Q4 Rank which elements of the Lacy Road Reconstruction Project are the most important to you? (1 - Most Important, 7 - Least Important) Note: *Goals cannot have the same rank, they must follow in order from 1 through 7*

Q19 What is your opinion of Alternative #1a - Urban Standard (66' right of way)?

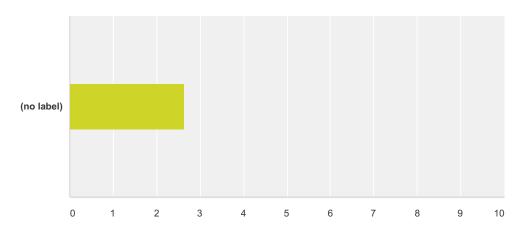
#	Responses	Date
1	This looks too much like a Fish Hatchery Road thoroughfare - too wide with unnecessary curb and gutter	9/18/2015 1:36 PM
2	Add storm water treatment	9/18/2015 9:49 AM
3	I wish it could be wider and that stop lights could be installed when coming down the hill near the busier library and city hall or caution lights- gets busy and people want to speed through this area- also HIGHLY encourage putting down near the railroad tracks safety measures- I think it is extremely dangerous and with growing population needs to be considered!	9/17/2015 10:43 PM
4	I don't like the narrow roads. It's dangerous for bikers and pedstrians.	9/17/2015 9:11 PM
5	I like the multi-use path being divided from the road.	9/17/2015 8:35 PM
6	without seeing the final design, we are blowing smoke	9/17/2015 7:44 PM
7	I believe a dedicated ped/bike path is safer. Families in my neighborhood would like to walk/bike to McGaw Park.	9/17/2015 3:56 PM

8	Round abouts to slow traffic and minimize speed	9/17/2015 11:58 AM
9	Lacy Road currently has many mature trees. Any sidewalk/path/swale design seems to indicate removing perhaps a majority of the trees. Many driveways are steep. These designs may cause difficulties for homeowners and the clutch in their vehicle.	9/16/2015 7:20 AM
10	Elimenate curb and cutter and Multi use path and terrace	9/15/2015 6:51 PM
11	Multi-use path is superfluous if bike lanes are added. For those uncomfortable biking on-road, there is an excellent network of paths along Research Park Dr.	9/14/2015 12:43 PM
12	I don't like a bike path that is on the road. I prefer that it be separate from the road.	9/14/2015 12:40 PM
13	Storm water must be addressed	9/14/2015 12:27 PM
14	This is a nominally urban area and an urban standard is unnecessary at this time.	9/13/2015 9:22 AM
15	We don't support the addition of curbs and gutters or multi-use lanes, however, if multi-use lanes are ultimately approved they should not be incorporated on both sides of the roadway.	9/13/2015 8:08 AM

16	Stormwater considerations	9/12/2015 10:49 PM
17	Double center lines all the way.	9/12/2015 8:03 PM
18	Given current traffic speeds, bike lanes don't leave enough space for bikers to be safe.	9/12/2015 5:01 PM
19	Separated bike paths are most ideal. Multi-use paths are OK but pedestrians do not pay attention and make them unsafe for cyclists.	9/12/2015 4:44 PM
20	Confusing section. We want to walk/bike safely out of the roadway from Syene to Fish Hatchery.	9/12/2015 4:24 PM
21	Not a fan of the curbs. It could be fine as long as the trees/bushes on the south side of Lacy Rd. are untouched and the sidewalk/path is on the north side.	9/12/2015 3:56 PM
22	way too wide, could case removal of beautiful trees that have defined the road. and it is a road not a street for many years	9/12/2015 11:37 AM
23	This is a poor question. I support trees, but not the terrace, and especially not a bike path. If biking is such a consideration, why isn't there more effort put into a bike path on Lacy between Seminole Hwy. & Fitchrona? I have traveled that route for 14 years, have seen numerous bicycles hit by cars, the hills you cannot see over, bicyclists use that path regularly and there are large construction vehicles on that road. That thoroughfare is a deathtrap to bicyclists.	9/12/2015 11:00 AM

24	The path is most important to me, and I don't care if it's sidewalk or multi use	9/12/2015 10:56 AM
25	A regular sidewalk would be sufficient instead of an oversized multi use path	9/11/2015 10:47 PM

26	We need bike paths and multi-use pathways. I'm very nervous biking and walking down Lacy.	9/11/2015 10:39 PM
27	I don't fully understand this. What is 66 vs 80 right of way? What does right of way mean in this context? I chose Support because it seems to indicate space for bikes and pedestrians, and that is what's most important to me.	9/11/2015 9:52 PM
28	Not much room within a 66' r/w for bike lanes, multi use path and terraces to fit trees, perhaps a smaller sidewalk would be more appropriate in this alternative	9/9/2015 1:37 PM
29	Bike Lanes would improve multi-modal transport and would connect with Fish Hatchery and new eastern developments. Currently, cycling on this stretch of Lacy is very dangerous (particularly westbound), as there is minimal or no curb and traffic moves at a high rate of speed over the hills.	9/9/2015 12:16 AM
30	Add another traffic lane or two not the bike junk. What an expensive waste of space.	9/8/2015 1:59 PM

39	This survey just deleted my answer I had typed after I pressed Next. (: Basically, see my prior answers and decide do we need that wide of a terrain? We may need some trees but use all existing trees. Is there parking on Lacy Road? I supported the side walk even though I did not check that box on about six screens earlier.	8/31/2015 11:51 AM
40	Why do we need multi-use paths if you already have a sidewalk and bike path?	8/30/2015 5:16 PM
41	I'd rather see bikes in path separated from car traffic, especially due to the visibility issues with the hill. I also don't like it that this option doesn't help the stormwater issues	8/30/2015 2:22 PM
42	How can one state a preference before being informed as to the other options? Poor survey design. And what about a "no preference" or "inadequate information" choice? Poor survey design leads to inaccurate conclusions or intentionally leads to a preferred outcome.	8/30/2015 11:41 AM

43	Consistent with Resolution 75-10 and previous promises and commitments made by the city to its citizens/taxpayers	8/30/2015 12:23 AM
44	We need walking paths that are not part of the street but as a regular sidewalk. Bike lanes can be part of the street. Like tree planting for beautification.	8/29/2015 12:34 PM
45	missing stormwater retention option	8/29/2015 11:13 AM
16	lose the curb	8/29/2015 9:47 AM
47	Bike lanes are not needed and are a complete waste of money if sidewalks OR a multi use lane are provided!	8/29/2015 7:23 AM
48	1. Build/plant sustainable storm water treatment within right of way. 2. Widen bike lane and/or build multi-path that serves needs of bicyclists. Bike lane width insufficient in 1a model!! 3. Be creative with current use of space, and avoid disruption of undeveloped land use wherever possible!	8/29/2015 7:09 AM
49	I believe this can be accomplished without curbs	8/28/2015 6:38 PM

62	seems that it needs to be wider for safety	8/26/2015 8:44 PM
63	Terrace of 10 feet is not needed.	8/26/2015 6:52 PM
64	If the path is indeed multi-use, then I see no need for a separate bike path	8/26/2015 1:26 PM
65	Improve Lacy without bike and pedestrian lanes which are inappropriate in consideration of heavy auto vehicle traffic.	8/26/2015 1:12 PM
66	Need better bike/ped accomodation. Complete lack of stormwater aspects is unacceptable	8/26/2015 12:36 PM
67	Add sidewalk	8/26/2015 11:39 AM
68	Boring, not as attractive as other alternatives.	8/26/2015 10:59 AM
69	Lacy road should retain a rural look not a urban design. Lacy road residents have never asked for or demanded to have our neighborhood changed to a rural design.	8/24/2015 3:54 PM
70	I support multi use path and 5foot bike lanes on the sides of Lacy rd	8/24/2015 3:10 PM
71	People who walk to/from destinations without sidewalk must cross road mid-blockseems dangerous at 35 (and 44!) MPH. Needs sidewalk. Improve bike lanes by using 1' curb header and 1' gutter instead of 6" curb header and 2' gutter. Use 10' travel lanes to calm traffic and reduce need for r.o.w.	8/23/2015 8:27 PM

72	don't like the multi-use path particularly, but since it would be across the street from my house it would be tolerable. I certainly wouldn't want it in front of my house.	8/23/2015 3:06 AM
73	Don't see need for multi use path.	8/22/2015 8:35 PM
74	I am concerned about flooding and also the impact to the existing trees	8/22/2015 8:27 PM
75	We need turn lanes into all the neighborhoods that are off of Lacy Road.	8/22/2015 4:13 PM
76	No comment	8/22/2015 1:58 PM
77	I support the bike lanes but not the curb and gutter. I don't think that their is a need for a multi use path the whole length of Lacy	8/21/2015 6:58 PM
78	repave with bike lanes only	8/21/2015 4:58 PM
79	The trees you plant will die from road salt. What about the 500 year old tree the city cut down at the corner of Lacy and Reseach Park?	8/21/2015 7:48 AM
80	If there is a multi use path, then I disagree that you need 2 bike lanes on the road.	8/20/2015 11:48 PM

81	Wider is better; this is a major east-west corridor	8/20/2015 6:41 PM

Q22 What is your opinion of Alternative #1 - Urban Standard (66' right of way)?

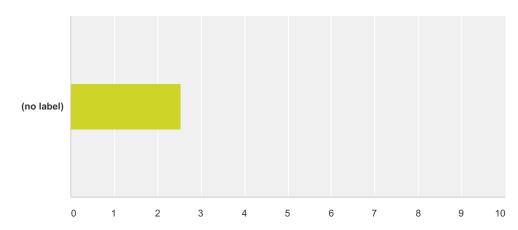
13	Way too much acquisition and expense for a sidewalk that is completely superfluous given on-road biking or multi-use path	9/14/2015 12:44 PM
14	Having separate byways for pedestrians, bicycles and motor vehicles seems like the safest option.	9/13/2015 11:50 AM
15	Stormwater concerns.	9/12/2015 10:50 PM
16	Double center lines all the way.	9/12/2015 8:08 PM
17	Sidewalk and multi-use path can accommodate both pedestrians and bikes. Most casual bikers would not use the bike lanes because they don't provide enough space.	9/12/2015 5:04 PM
18	Sidewalk on one side, bike path on other side would be good.	9/12/2015 4:46 PM
19	Multi-use path and/or sidewalk needs to be OUT of the street. Car speed is too fast. Increased de-velopment means even more traffic	9/12/2015 4:26 PM
20	Same as before. Not a fan of the curbs, but it could be fine as long as the trees/bushes on the south side the 54XX address block are untouched.	9/12/2015 4:02 PM

21	Again, another poorly worded question. Lesser of all evils would be having a sidewalk, then bike path, but definitely keeping the trees. QuestionIf there is so much concern about all the new traffic coming, why encourage bikers, especially on a road with roundabouts, stop areas, etc? It's already hard to pull out of Mica onto Lacy road. Bikes would be in more danger I would think.	9/12/2015 11:02 AM
22	How beneficial are the trees besides aesthetics? It seems like unnecessary spending on landscaping	9/11/2015 10:48 PM
23	Same comments as previous, 66' is not wide enough to accommodate all these things.	9/9/2015 1:38 PM
24	Sidewalks would require greater right of way acquisition from property owners and seem to be redundant if there is a MUP.	9/9/2015 12:18 AM

·	
25	What is being achieved here? Again, the City is going to make improvements to a roadway THAT DON'T IMPROVE THE ROADWAY!! Reminds me of the horrible decision to not add lanes to Fish Hatchery south of Lacy Road. A real idiot designed that debacle.	9/8/2015 2:01 PM
26	Sidewalk not necessary if there is a multi-use path.	9/8/2015 11:47 AM
27	Like but don't see the need for sidewalk AND path AND bike lanes.	9/8/2015 11:39 AM
28	Want bike path that is safe - not in the road	9/7/2015 11:56 PM
29	wider bike lanes. Narrower terrace. Create narrower view line, reducing traffic speeds	9/7/2015 2:14 PM
30	I like that there is a multiuse path to separate bikers and cars	9/1/2015 1:56 PM
31	You do not need a bike lane, a sidewalk, and a multi-use path - the path will work for all three	8/31/2015 1:42 PM
32	All okay	8/31/2015 12:12 PM
33	The survey keeps deleting my text.	8/31/2015 11:53 AM
34	would prefer multi-use path to include bikes and peds. prefer stormwater features of other alternatives	8/30/2015 2:23 PM

43	Why not consider speed bumps?	8/28/2015 4:35 PM
44	Side walk seems unnecessary, but if it can be done without too much impact on private property, I would be in favor of it.	8/28/2015 9:15 AM
45	more grass to mow and maintain	8/28/2015 8:42 AM
46	One thing to note would be that pedestrians and bicycles should be separated somehow. The speed difference between a cyclist traveling at 17mph and a pedestrian at 3mph is just as big as between a cyclist traveling at 17 and a car traveling at 30.	8/28/2015 8:14 AM
47	I'm not sure how much this differs from the prior question	8/28/2015 12:30 AM
48	Bike lanes need to be 1 foot wider	8/27/2015 4:45 PM
49	either sidewalk or multi-purpose path. I don't think both are needed and path would seem to be better option	8/27/2015 9:39 AM
50	Again, narrow bike lines though I do support them in general. I prefer the multi-use path to the sidewalk and I don't feel that both are needed. Multi-use path makes more sense than sidewalks.	8/27/2015 9:17 AM

59	sidewalk or multi-use path is sufficient, don't need both	8/26/2015 11:07 AM
60	Prefer multi-use path to bike lane because I feel it is much safer. Would like a bike lane if no multi use path was available. Sidewalk is crucial!	8/25/2015 2:09 PM
61	i don't think we need both a sidewalk and a multi-use path. the multi-use path would be more friendly to families or small children on bikes or disabled adults with mobility devices.	8/24/2015 8:47 PM
62	I am not supporting anything because I do not like this design at all.	8/24/2015 3:55 PM
63	Multi use ped/bike path 5 foot bike lane on each side of road. No sidewalks	8/24/2015 3:12 PM
64	People who walk to/from destinations without sidewalk must cross road mid-block—seems dangerous at 35 (and 44!) MPH. Needs sidewalk. Improve bike lanes by using 1' curb header and 1' gutter instead of 6" curb header and 2' gutter. Use 10' travel lanes to calm traffic and reduce need for r.o.w.	8/23/2015 8:28 PM

65	this is awful, complete waste of property & space	8/23/2015 10:59 AM
66	I like the additional trees in this design, but it needs either the sidewalk or the path to keep it functional. I don't think it needs both if that would result in more downed trees.	8/22/2015 8:27 PM
67	If I had to choose based on space, I'd rather have the multi- use path than bike lanes.	8/22/2015 4:15 PM
68	I like that there is path/sidewalk on either side of the road.	8/22/2015 8:14 AM
69	Without the sidewalk or multi use path I don't see a difference to the previous	8/21/2015 7:00 PM
70	repave with bike lanes only	8/21/2015 4:59 PM
71	Again, this survey does not contain any traffic calming devices. Why not?	8/21/2015 7:50 AM
72	There is no need for a multi use path, sidewalk, and 2 bike lanes. That is extremely redundant, expensive, and disturbing to residents.	8/20/2015 11:51 PM
73	This needs to be done right. People move to Fitchburg because of it's excellent accommodation of pedestrian-bicycle transportation. Research shows property values along bike trails go up, benefiting adjacent landowners.	8/20/2015 6:45 PM

Q25 What is your opinion of Alternative #2 - Stormwater Terraces (73' right of way)?

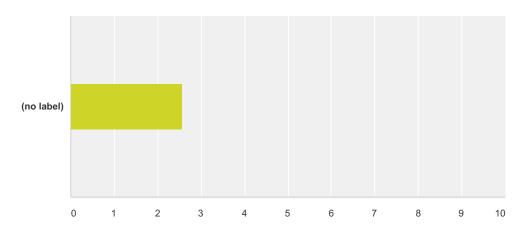
9	I think you need both a multi-use path and a bike lane as some bikers refuse to use a multi-path lane. I don't think a side walk is needed. I like the bioretention ponds. I think Fitchburg does a great job managing it's bioretention areas.	9/15/2015 9:29 AM
10	Again, I don't think a sidewalk is necessary if a multi-use path is there. Like the storm retention system.	9/14/2015 6:52 PM
11	Way too much acquisition when needs could be met with bike lanes. I don't know enough about the stormwater terraces (who maintains them? who pays for them?) to comment.	9/14/2015 12:46 PM
12	Unnecessary currently and expensive with concerns about project maintenance long-term	9/13/2015 9:23 AM
13	Double center lines all the way.	9/12/2015 8:09 PM
14	Need both sidewalk and multi-use path to accommodate pedestrians and bikers.	9/12/2015 5:06 PM
15	Biking is best on multi-use trail, not on lane-side bike lanes.	9/12/2015 4:47 PM

16	People should NOT be walking in the street. People should be able to USE the corridor SAFELY.	9/12/2015 4:28 PM
17	Seems fine as long as the trees/bushes on the south side the 54XX address block are untouched.	9/12/2015 4:03 PM
18	Too wide	9/12/2015 2:03 PM
19	Are the terraces necessary?	9/12/2015 12:39 PM
20	Another poorly worded question.	9/12/2015 11:03 AM
21	Lots of money for how much real use and necessity?	9/11/2015 10:49 PM
22	Make sure landscaping in the stormwater terraces don't impact visibility	9/9/2015 1:39 PM
23	YOU COULD MAKE LACY A FOUR LANE ROADWAY FOR LESS SPACE AND COST	9/8/2015 2:03 PM
24	I *support* this, but I don't really need the Sustainable Bioretention Elements.	9/8/2015 12:04 PM
25	Again, no need for curb and gutter and a sidewalk if there is a multi-use path. Not on Survey, but bury the power lines.	9/8/2015 11:48 AM
26	wider bike lanes and narrower bioswale	9/7/2015 2:15 PM

41	Bike lanes need to be 1 foot wider	8/27/2015 4:46 PM
42	This is it	8/27/2015 3:48 PM
43	Would be nice to have trees on both sides of the roadway. Also concerned that the bioretention swales would not be be attractive without above -average maintenance attention. If these are used, rain-garden plants should be established and ongoing maintenance planned.	8/27/2015 3:07 PM
44	Again, I don't feel that a sidewalk and muti-use path are necessary. On a side note, I don't know anyone that would want to buy a house directly across from what appears to be industrial or commercial storage on the rendering.	8/27/2015 9:18 AM
45	get ride of sidewalks and bike lanesthat is what a multi-use path is for.	8/27/2015 8:57 AM
46	Combines natural elements with the bike path and sidewalk. Storm drain option seems most logical.	8/27/2015 6:59 AM
47	It has the very undesirable - hated SIDEWALK. A sidewalk and a multi-use bike-ped path are redundant. It has the unnecessary bioretention ditch. Almost ALL of Lacy road has a downhill pitch to the west or to the east. Put some water in this ditch, and it will flow downhill, and the water stream will dig and channel and erode and pick up soil as it flows down to a pond or whatever destination you think of to use. The pond, or any destination will be accumulating all this sediment.	8/27/2015 1:31 AM

58	complete waste of property & space	8/23/2015 10:59 AM
59	keep trees on both sides of the road	8/23/2015 3:09 AM
60	I like the sustainable flooding aspect, and I do think it needs at least one path. I would pick the multi use path under the trees since then it would be a nicer, shady walk.	8/22/2015 8:36 PM
61	I would prioritize safe walking path above everything else.	8/22/2015 4:17 PM
62	Storm water terraces are an important feature without which residents may experience flooding problems in the future.	8/22/2015 9:13 AM
63	While losing trees is never great, the Swales seem to be an attractive way to deal with storm water.	8/22/2015 8:15 AM

0.4		0/00/0045 7 00 444
64	Too big	8/22/2015 7:33 AM
65	they will not be sustainable. They will become weed beds not maintained by anyone.	8/21/2015 5:39 PM
66	repave with bike lanes only	8/21/2015 5:00 PM
67	Have you considered buying all the houses on Lacy Road and then you could build your major corridor?	8/21/2015 7:51 AM
68	There is no need for a multi use path, sidewalk, and 2 bike lanes. That is extremely redundant, expensive, and disturbing to residents. The storm water terraces also add unnecessary right of way accusations and do not look good.	8/20/2015 11:53 PM

Q28 What is your opinion of Alternative #3 - Stormwater Median (86' right of way)?

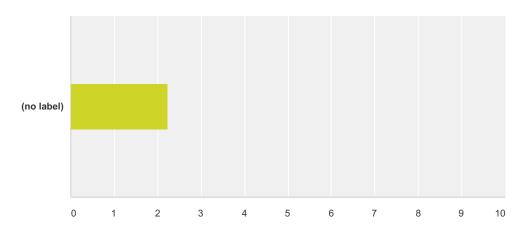
8	I feel like it's harder for cars to give bicyclists comfortable clearance when there's a median.	9/16/2015 2:07 PM
9	This option takes more space, more trees lost, already steep driveways made more difficult. I question the need for paths on both sides of the road.	9/16/2015 7:26 AM
10	Absolutely hate this plan.	9/15/2015 6:56 PM
11	Very nice design. It would be safer for both drivers and bikers with having median strip down the middle. I often think about head on collisions on Lacy. This deals with this issue. This is my favorite design, minus the sidewalk.	9/15/2015 9:31 AM
12	No sidewalk needed. Downside of this plan is destruction of existing elements (trees, e.g) as the plan is so wide.	9/14/2015 6:54 PM
13	Way, way too much acquisition, and a total departure from rural nature of Lacy Road.	9/14/2015 12:46 PM
14	I like the look of this with the trees.	9/14/2015 12:43 PM
15	This seems to me to be the best option.	9/13/2015 11:52 AM

16	Acquisition costs	9/12/2015 10:51 PM
17	Nice median.	9/12/2015 8:10 PM
18	Too wide. Would take too much from residences on Lacy Road.	9/12/2015 5:07 PM
19	WHY ARE SIDEWALKS/MULTI-USE PATHS ALWAYS OPTIONAL? MANDITORY, then decide the rest.	9/12/2015 4:30 PM
20	Seems like you'd have to widen the road too much. Could make it difficult to make left turns out of driveways.	9/12/2015 4:05 PM
21	I believe any widening of the road and bike lane infrastructure would damage trees and encroach too closely to my home	9/12/2015 3:46 PM
22	Seems to require too much change and costs	9/12/2015 12:40 PM
23	What are you thinking? this is ridiculous	9/12/2015 11:38 AM
24	Too wide. Takes away too much from current homes along Lacy.	9/12/2015 11:04 AM
25	I would want to see studies demonstrating the safety of introducing a new, wide median before supporting this option.	9/12/2015 8:53 AM
26	Ridiculously involved. Unnecessary and expensive.	9/11/2015 10:49 PM

29	Although I'm sure this is the most costly of the options I think it is also one of the safest options. I would want to see actual costs before making a final decision. Also since I do not own property on Lacy Rd it would not impact me directly as it would residents along Lacy Rd.	9/9/2015 10:18 AM
30	Dislike the overall plan as opposed to individual elements. I believe the median is unnecessary, would require acquisition of private property, and may lead to increased speeds, as it seems to create a boulevard.	9/9/2015 12:20 AM
31	This survey is so slanted which do you prefer: the bad option, really bad option, or the one that a room full of chain-smoking monkeys with typewriters dreamt up? What a money wasting joke!	9/8/2015 2:04 PM
32	Again, I *support* this, but don't need the Sustainable Bioretention Elements.	9/8/2015 12:05 PM
33	Way too much going on there.	9/8/2015 11:49 AM
34	Visually this alternative is the best!	9/8/2015 8:28 AM

46	Having the bioretention element in the median adds safety, lowers glare from oncoming traffic, an increasing problem for aging eyes for our aging population.	8/29/2015 11:16 AM
47	Bike lanes are not needed and are a complete waste of money if sidewalks OR a multi use lane are provided!	8/29/2015 7:23 AM
48	Alternative #3 superior design! Where right of way acquisition is necessary, prefer as little disruption to undeveloped land as possiblemodifying pathways/plantings to fit current landscape wherever possible.	8/29/2015 7:15 AM
49	Curbs are not essential. A bermed median would be adequate	8/28/2015 6:41 PM
50	This would be an option, only if you bought all the houses on Lacy road, then you would not have any driveways. That is what you want, right?	8/28/2015 4:39 PM
51	I very much like the appearance of this option, but I don't want to ruin the front yards of the homes on Lacy Road.	8/28/2015 9:17 AM

52	more grass to mow and maintain	8/28/2015 8:44 AM
53	not sure about advantages/disadvantages of bioretention elements	8/28/2015 12:33 AM
54	Bike lanes need to be 1 foot wider	8/27/2015 4:46 PM
55	Median creates lack of cross-traffic movement that could hinder bicycle and pedestrian movement	8/27/2015 3:48 PM
56	Concerned that the medians would not be be attractive without above -average maintenance attention. If these are used, rain-garden plants should be established and ongoing maintenance planned. Just grass or mud/muck/weeds not acceptable.	8/27/2015 3:07 PM
57	This design might encourage higher vehicular speeds	8/27/2015 2:29 PM
58	I appreciate the additional green space in this option. I still don't think a sidewalk and path are necessary if budget constraints don't allow for both.	8/27/2015 9:19 AM
59	Safe and pretty. Lasting value to the community.	8/27/2015 7:25 AM
60	This will require pass throughs and limits options in emergency situations. With the firehouse on Lacy, it seems this would limit their ability to get thru traffic.	8/27/2015 7:00 AM

73	I like incorporating all elements. I do not have a strong preference on whether the stormwater median is placed in the median or to one side. I prefer a multi-use path and side walk as the safest option for bikers and pedestrians but would additionally support bi directional bike lanes.	8/25/2015 2:13 PM
74	do not like layout	8/25/2015 12:01 PM
75	would lose way too many trees and yards by almost doubling the size of the roadway. do not need both a sidewalk and a multi-use path and prefer multi-use path.	8/24/2015 8:50 PM
76	I did not support anything because this design is way out of line for what us residence on Lacy road want or need.	8/24/2015 3:59 PM
77	Nice idea where ample r.o.w. is available. Needs sidewalk. Needs multi-use path. Improve bike lanes by using 1' curb header and 1' gutter instead of 6" curb header and 2' gutter. Use 10' travel lanes to calm traffic and reduce need for r.o.w.	8/23/2015 8:32 PM

78	unnecessary	8/23/2015 11:00 AM
79	not in favor of any property acquisition	8/23/2015 3:10 AM
80	Way too wide, and not liking the median especially since it is only a two lane road.	8/22/2015 8:36 PM
81	I think that having storm water terraces on each side makes more sense.	8/22/2015 9:14 AM
82	Having a median is nice and would probably improve safety.	8/22/2015 8:17 AM
83	Too big	8/22/2015 7:33 AM
84	repave with bike lanes only	8/21/2015 5:00 PM
85	NO MEDIANS Please. There are WAY too many residences that would require cuts. The alternative would be to restrict the residents of Lacy Road to one way in or out of their homes.	8/21/2015 1:24 PM
86	What is the safety factor when walking out of your house into traffic? Who would want to live here?	8/21/2015 7:52 AM
87	There is no need for a multi use path, sidewalk, and 2 bike lanes. That is extremely redundant, expensive, and disturbing to residents. The median adds nothing except cost, maintenance, and width to the road.	8/20/2015 11:55 PM

Q31 What is your opinion of Alternative #4 - Rural Stormwater (80' right of way)?

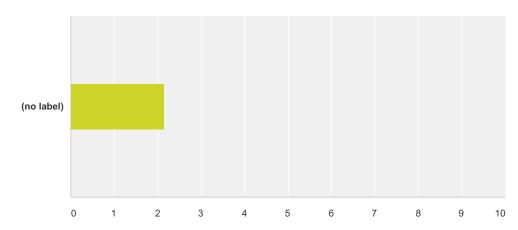
10	Prefer trees on both sides of the road	9/14/2015 12:44 PM
11	The only reason I don't support the bike lanes is that I think it is much safer to have the bikes on a separate path.	9/13/2015 11:53 AM
12	Why are we focusing City resources on this project????	9/13/2015 9:24 AM
13	Cost of acquisition	9/12/2015 10:51 PM
14	Too much bioretention.	9/12/2015 8:11 PM
15	Too wide. Need both sidewalk and multi-use path	9/12/2015 5:10 PM
16	Add water-tolerant trees to retention strip. Black ash and eastern larch would be unique.	9/12/2015 4:49 PM
17	Always optional for sidewalk & multi-use path? Trees, swales, etc. won't get people safely up Lacy to use city bldgs.,library, businesses. People 1st!	9/12/2015 4:32 PM
18	Seems like the rural bioretention would cut too far into people's properties.	9/12/2015 4:07 PM
19	still stupid, you can't fix stupid. which properties lose much of their value to this pile of st	9/12/2015 11:39 AM

53	completely unnecessarycostly and poor use of land. Destroys neighborhood and negatively impacts property values along the corridor.	8/23/2015 11:00 AM
54	too much of my front yard would have to be acquired I don.t want the street any closer to my house	8/23/2015 3:13 AM
55	I don't like thatit requires acquisitions and that the bioretention area is so much bigger with no trees.	8/22/2015 8:36 PM
56	I would prefer saving trees on both sides of the road.	8/22/2015 9:16 AM
57	The bioretention Swales seem much more efficient.	8/22/2015 8:18 AM
58	Too big	8/22/2015 7:33 AM
59	repave with bike lanes only	8/21/2015 5:01 PM
60	Why is there not a Glacier Valley option?	8/21/2015 7:55 AM

61	There is no need for a multi use path, sidewalk, and 2 bike lanes. That is extremely redundant, expensive, and disturbing to residents. The rural storm water area does not look good, adds unnecessary cost and right of way accusations.	8/20/2015 11:57 PM
62	This is probably pushing the reconstruction to a point where Lacy Road resident opposition will be overwhelming. I would however prefer this if it was possible.	8/20/2015 6:48 PM
